**From:** [REDACTED]  
**To:** [REDACTED]  
**CC:** [REDACTED]  
**Sent:** 2/24/2021 5:13:42 PM  
**Subject:** FW: O8W-PM [REDACTED] - Bucks Creek 1101 Phase 1,2&3 -  
Pre-Engineering Meeting  
**Importance:** High

Subject: O8W-PM [REDACTED] Bucks Creek 1101 Phase 1,2&3 - Pre-Engineering Meeting

# Bucks Creek 1101- PM# [REDACTED] Overview Map

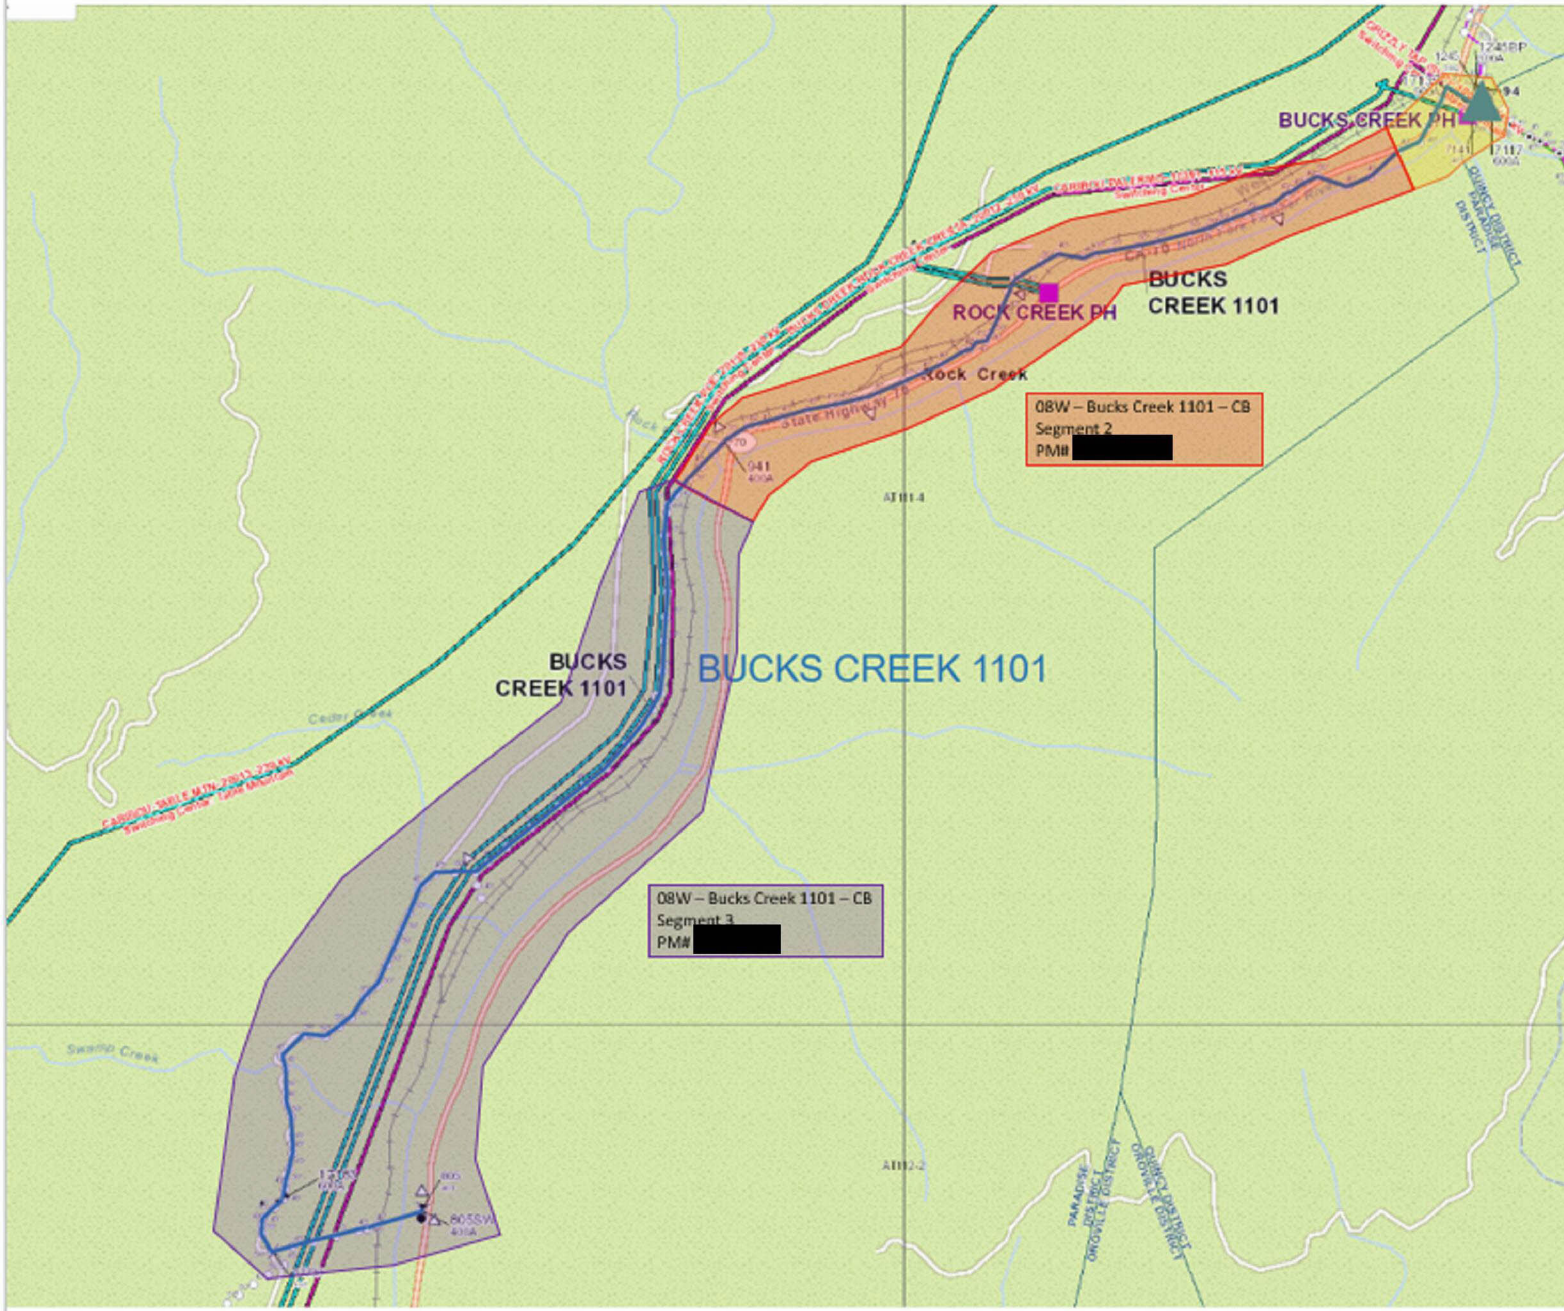
For Bucks Creek there is quite a bit of work surrounding Hwy 70 and we will need a Land Department Base Maps prepared for all 3 Orders. This will delay the EOD dates until these can be developed and provided to the Vendor... We will also need answers to the questions outlined by [REDACTED] below...
